BID # 1253

BID PACKAGE
FOR
REHABILITATION/RECONSTRUCTION WORK TO
MASURY RESIDENCE
31 MOREHOUSE AVENUE
MILFORD, CONNECTICUT

ADDENDUM NO. 1

② South Elevation
1/4"=1'-0"

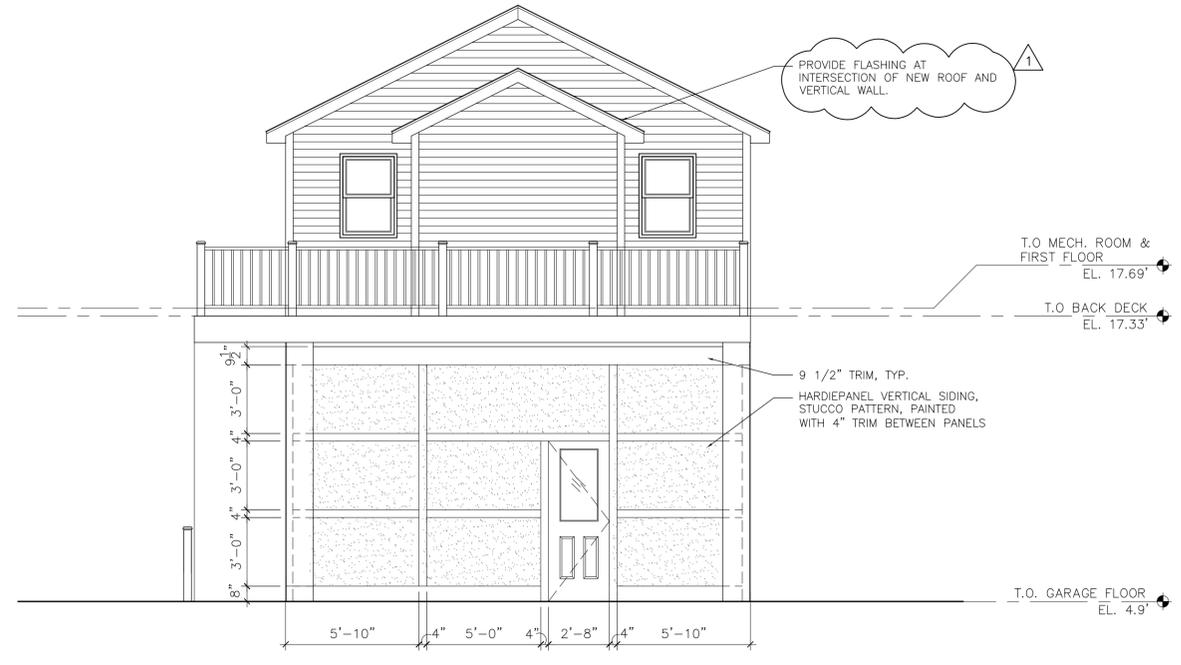
1. Drawing D-101 First Floor Demolition Plan
 - a. Demo Note #3 should read: Remove existing window **STOOLS**, store for re-installation after renovation.
2. Drawing A-102 Exterior Elevations
 - a. Drawing 2 – South Elevation: Provide flashing at intersection of new roof and vertical wall.
 - b. Drawing 3 – West Elevation:
 - i. Additional post added at back deck, Trex Transcend Railing is available in 6'-0" and 8'-0" lengths.
 - ii. Stair railings changed to Trex Reveal Series Railing with 2"x2" crossover posts in order to allow for a continuous railing.
3. Drawing A-102 Exterior Elevation & Plan Detail
 - a. Drawing 1 – East Elevations

① East Elevation
1/4" = 1'-0"

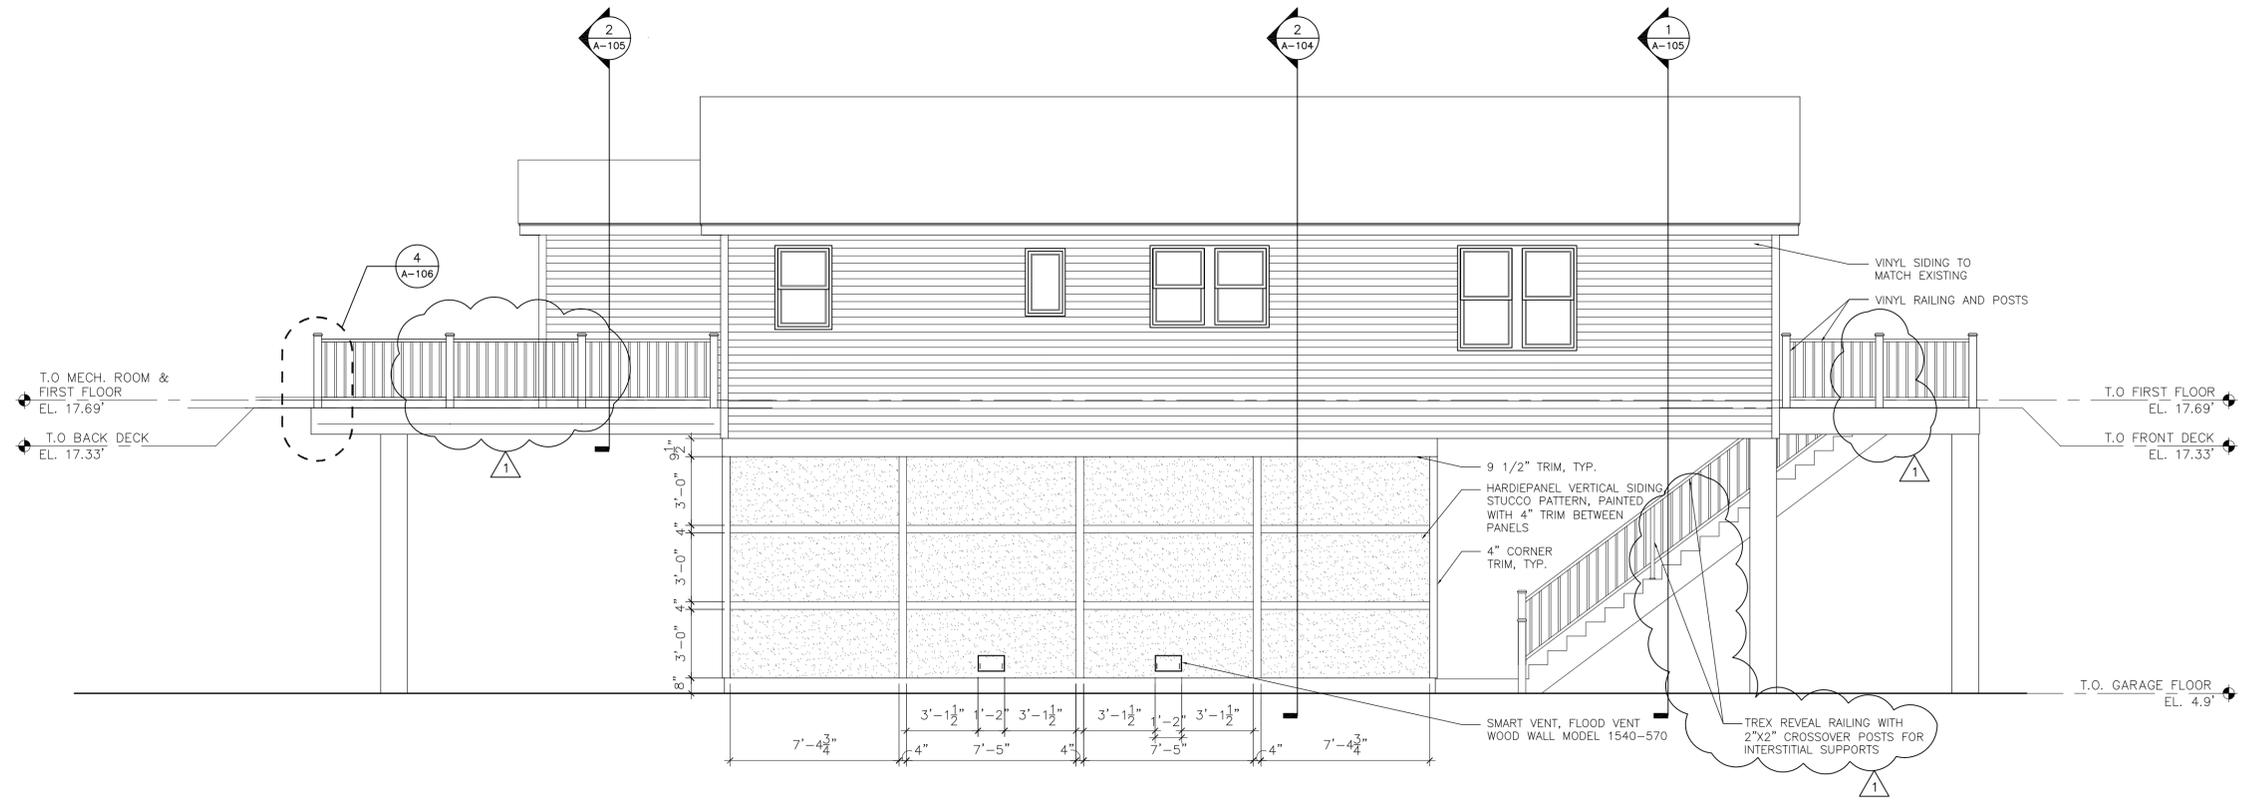
- i. Additional post added at both front and back decks, Trex Transcend Railing is available in 6'-0" and 8'-0" lengths.
 - ii. Stair railings changed to Trex Reveal Series Railing with 2"x2" crossover posts in order to allow for a continuous railing.

Sections & Details

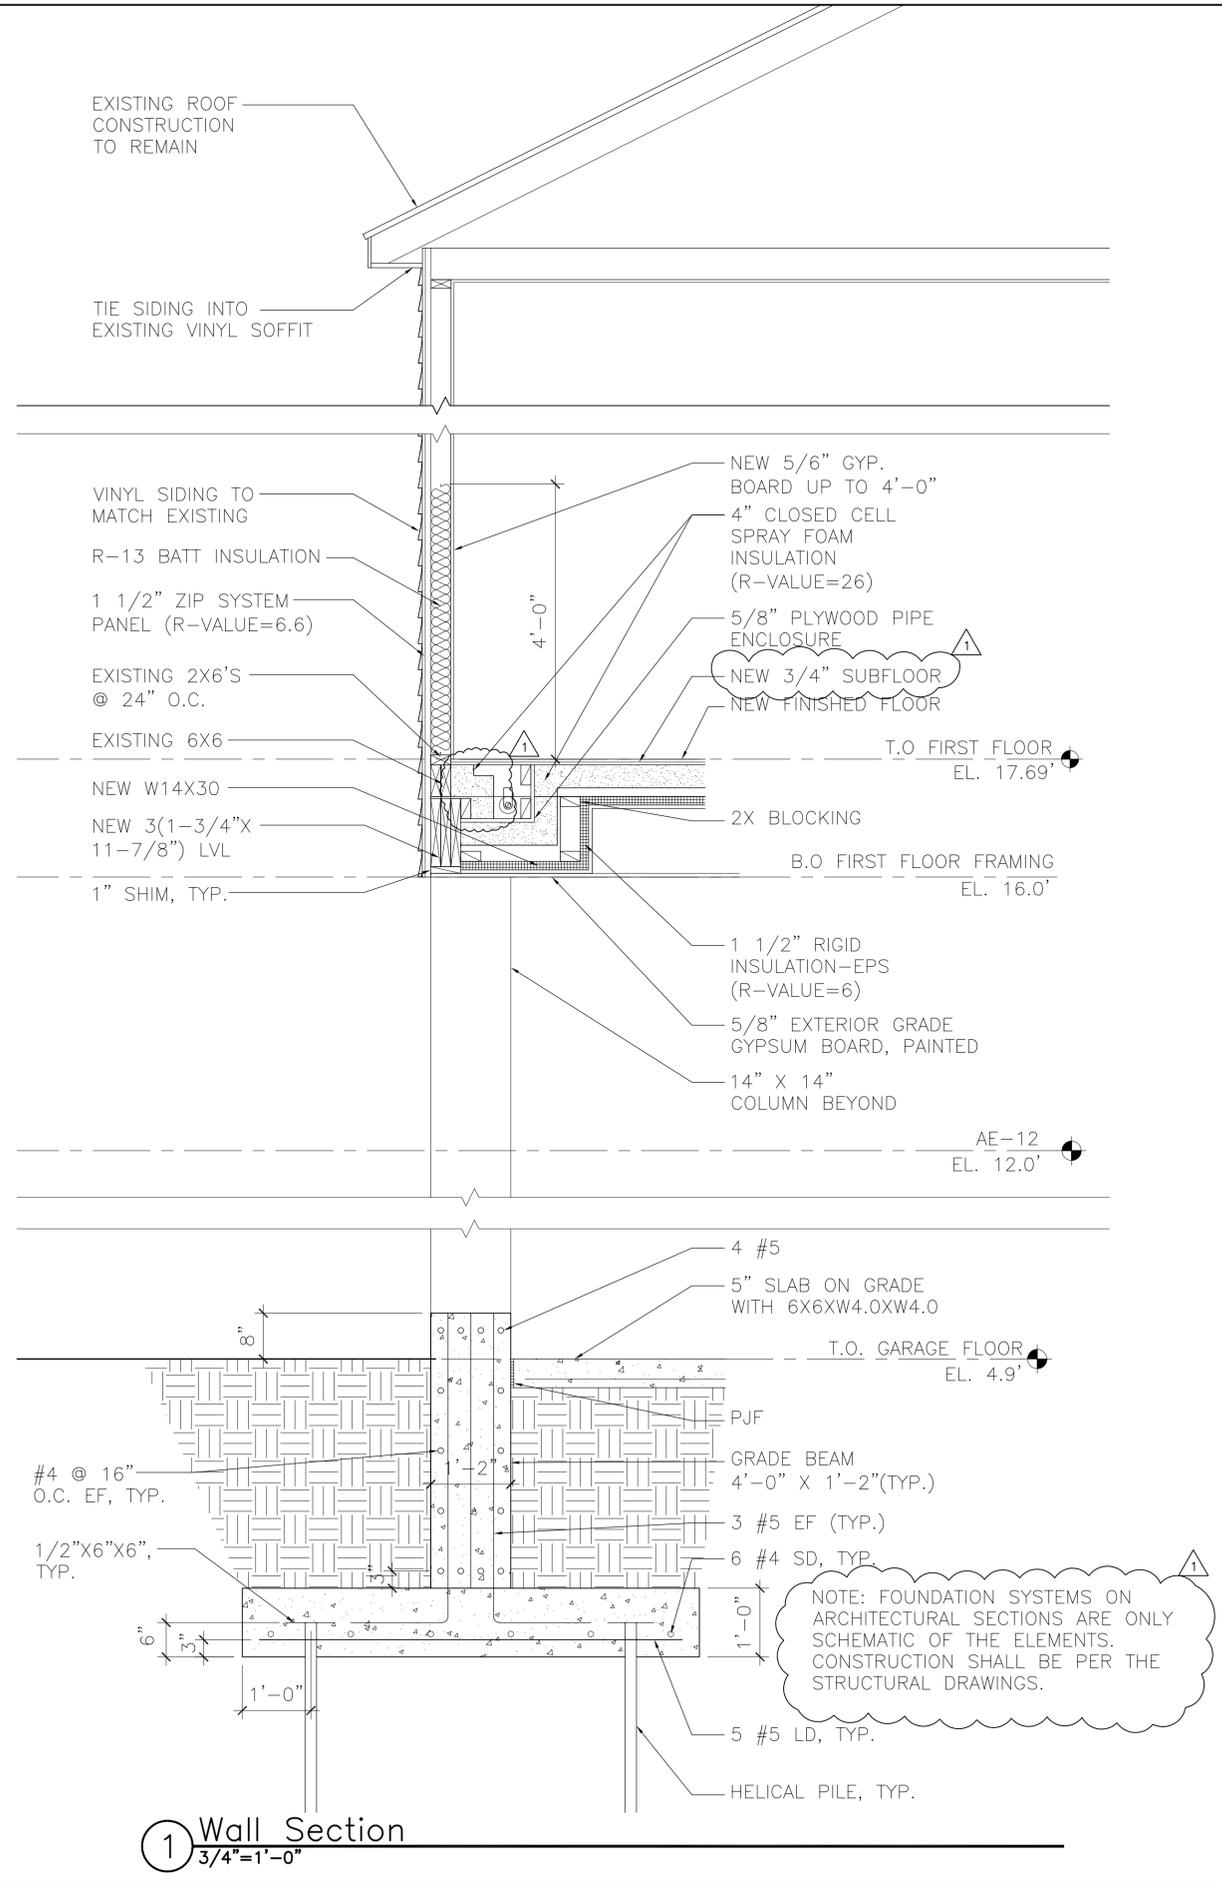
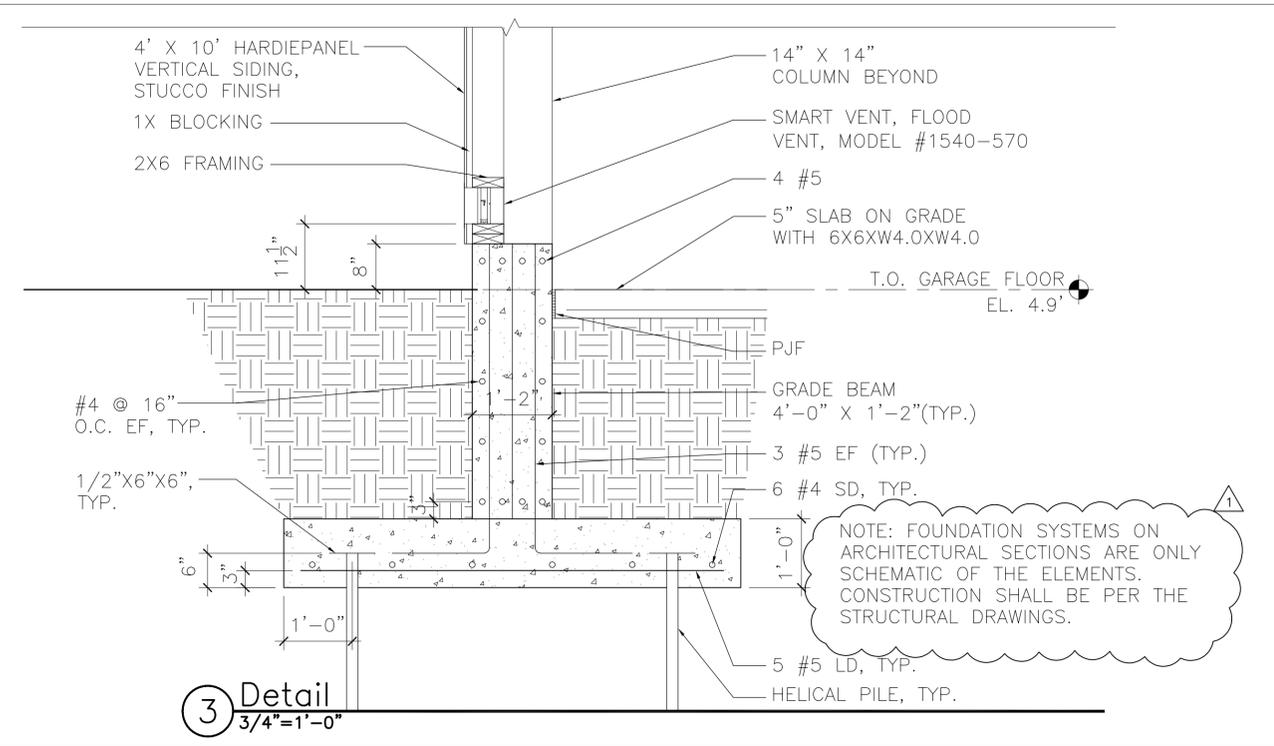
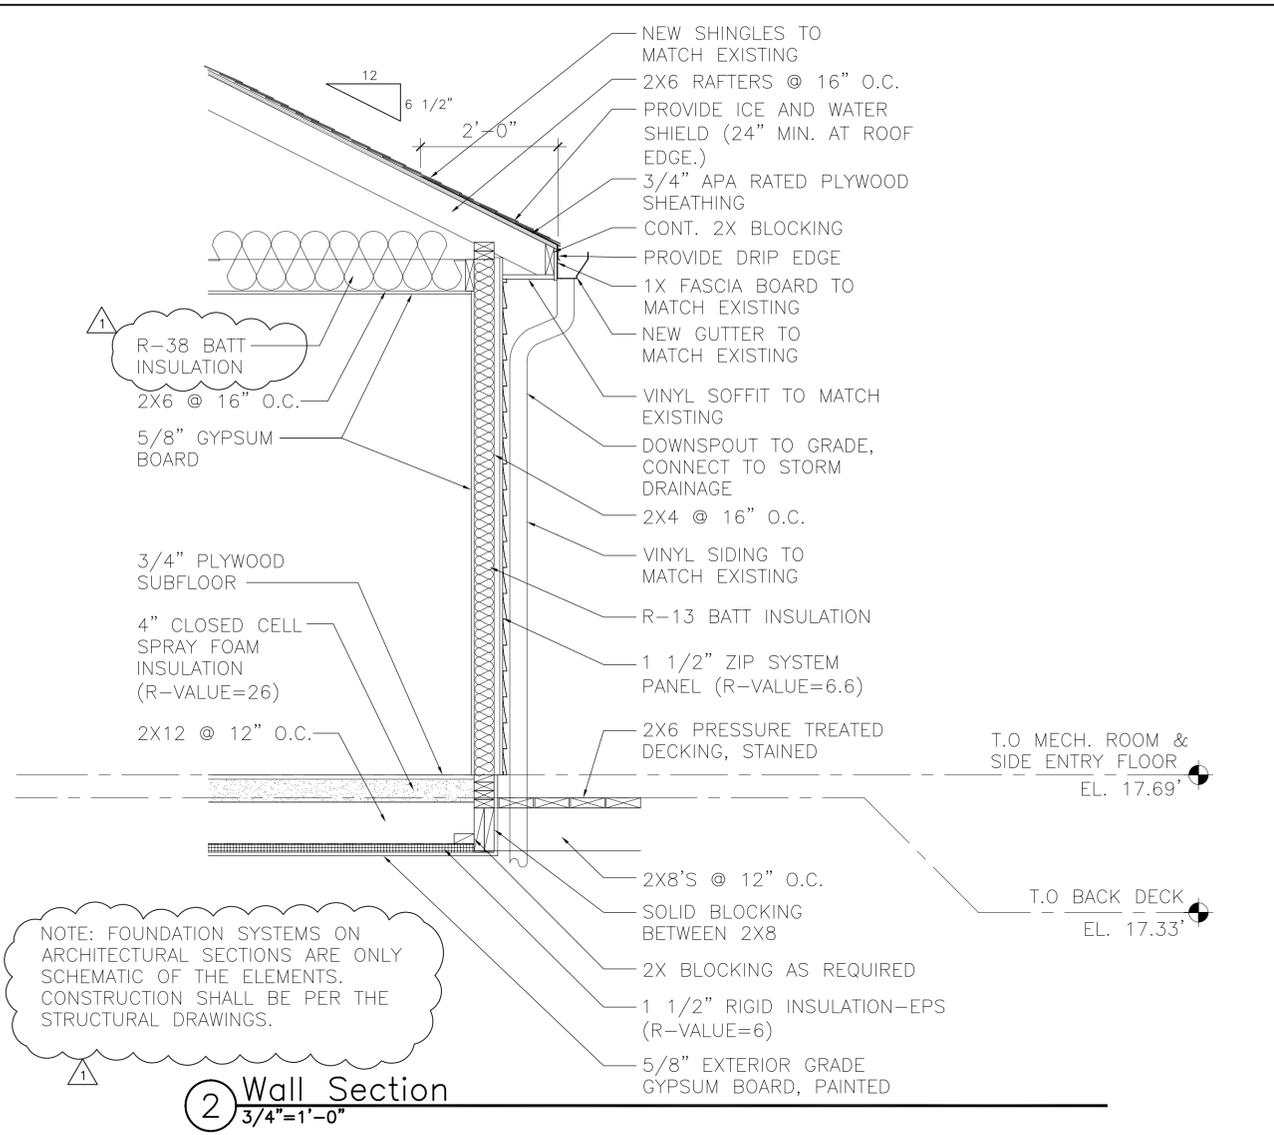
- 4. Drawing A-104 – Sections & Details
 - a. Drawing 1 – Section
 - i. Center LVL beam to be wrapped with 1 ½" rigid insulation and 5/8" exterior grade gypsum board.

- ii. Note Added: Foundation systems on architectural sections are only schematic of elements. Construction shall be per the structural drawings.
 - b. Drawing 2 – Wall Section

- i. Provide new ¾" subfloor at first floor.
 - ii. Provide additional spray foam insulation at perimeter portion of plywood pipe enclosure.
 - iii. Note Added: Foundation systems on architectural sections are only schematic of elements. Construction shall be per the structural drawings.

③ Stair Detail
1/4"=1'-0"

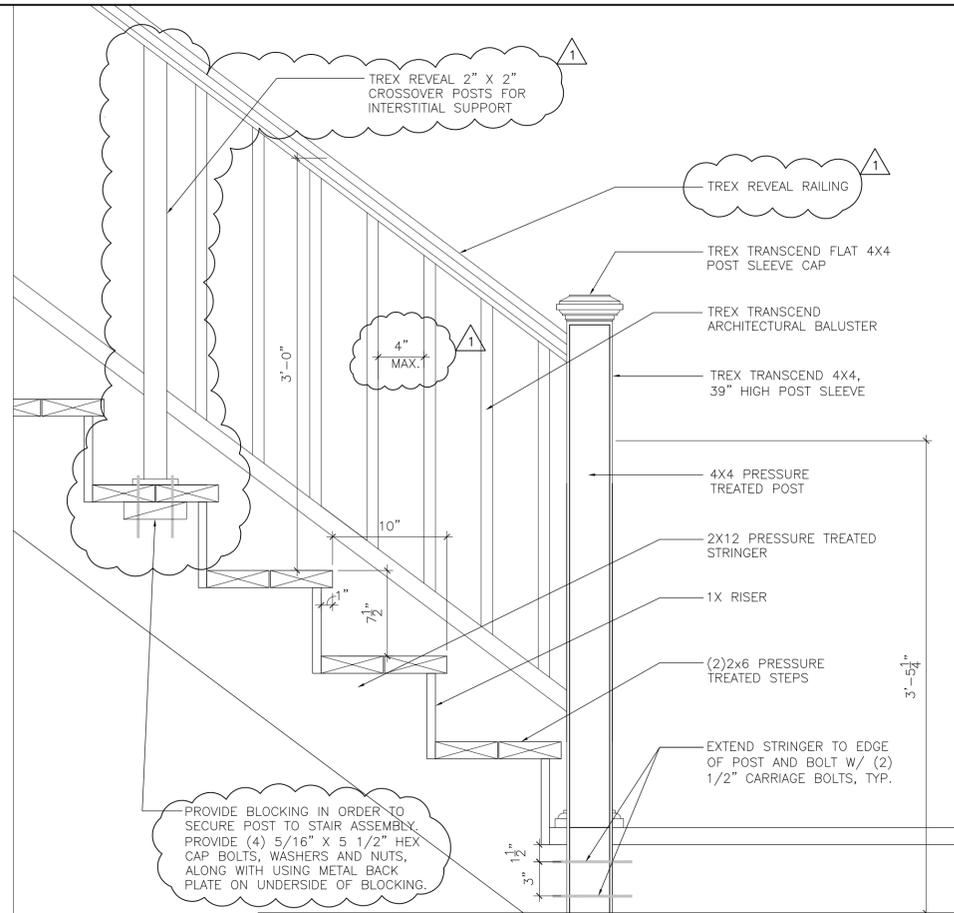
- i. Dimension between balusters is 4" Max.
 - ii. Stair railings changed to Trex Reveal Series Railing with 2"x2" crossover posts in order to allow for a continuous railing.

② Back Deck Post Layout
1/4"=1'-0"

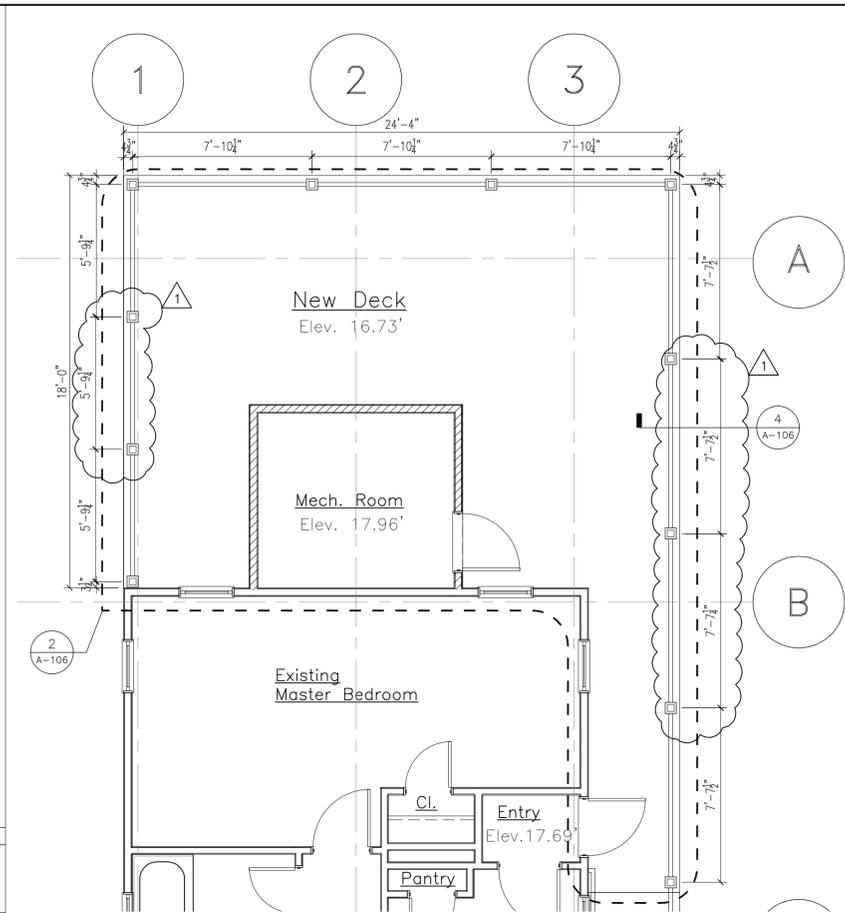
- b. Drawing 2 – Back Deck Post Layout
 - i. Additional posts added at back deck, Trex Transcend Railing is available in 6'-0" and 8'-0" lengths.
 - c. Drawing 3 – Stair Detail

① Front Deck Post Layout
1/4"=1'-0"

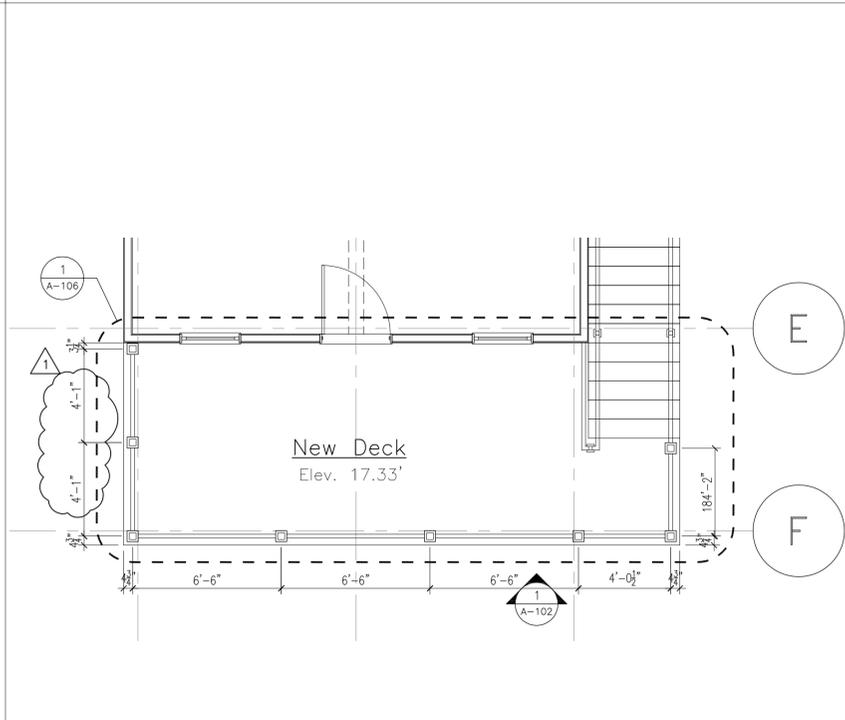
- 6. Drawing A-106 – Deck and Stair Details
 - a. Drawing 1 – Front Deck Post Layout
 - i. Additional post added at front deck, Trex Transcend Railing is available in 6'-0" and 8'-0" lengths.
